MEMORANDUM

To UNISIG
From Swiss ETCS System Manager, author: Bettina Wilhelm, SBB, I-AT-SAZ
Date 09.09.2019
Topic **Partial Implementation of CR782 in Switzerland**

Figure 1: Real train front end versus confidence interval

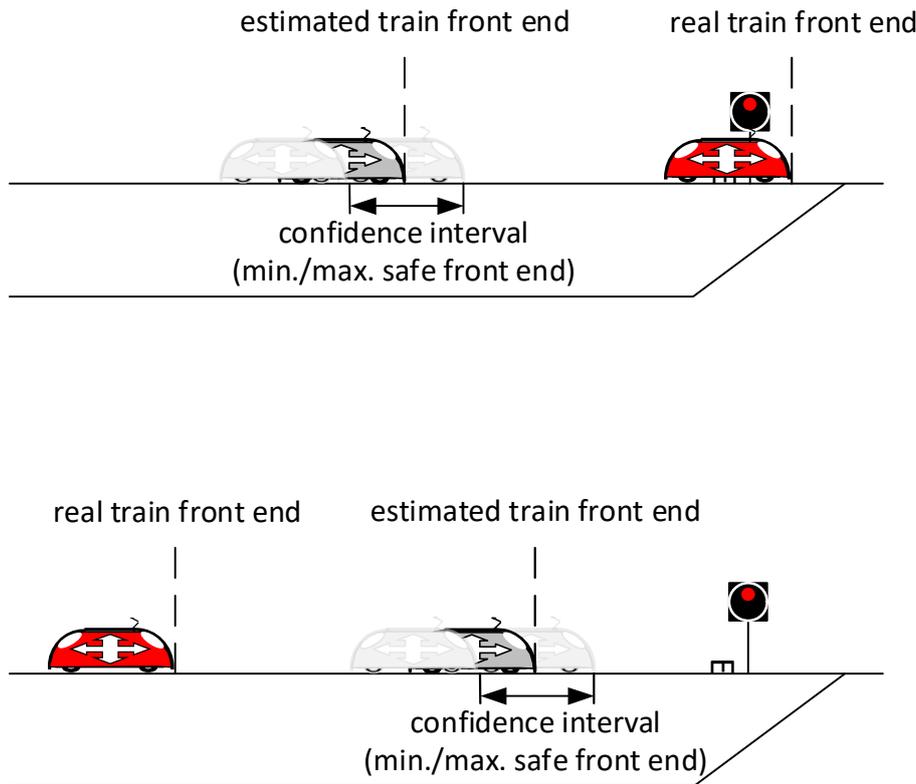
In case no linking is available on-board, the relocation is performed nevertheless by assuming the estimated distance corresponds to the distance travelled. Similarly, the confidence interval is reset using the national or default value for the location accuracy. As both, the estimated distance and the national or default value for the location accuracy, can differ from reality, the real train front end can be outside the confidence interval after such a relocation. Depending on the real train front end being in advance or in rear of the confidence interval the consequences in target speed monitoring will be (see figure 1):

- The ETCS intervention (emergency brake or train trip) happens too late and the train can pass the danger point.
- The ETCS intervention happens too early and the train is braked unnecessarily or even tripped before reaching the signal at the end of the movement authority.

Both consequences are not acceptable in operation. While a delayed ETCS intervention will lead to a potentially hazardous situation clearly affecting the safety, a premature ETCS intervention will negatively affect the stability and performance of the railway operation.

- Req. 1 CR782 [2] shall only be partially implemented, i.e. the paragraphs 3.6.4.3 b), 3.6.4.7.1 and 3.6.4.7.2 of Subset-026 [3] shall not be implemented.
- Req. 2 Instead the OBU supplier shall implement the relocation and reset of confidence interval in a safe way also for an unlinked balise group or for a linked balise group in case no linking is available on-board.
- Req. 3 The supplier shall analyse the chosen solution to ensure there are no unmitigated risks. Mitigation measures, if any, shall be addressed to the vehicle owner or rolling stock operator as exported constraints.
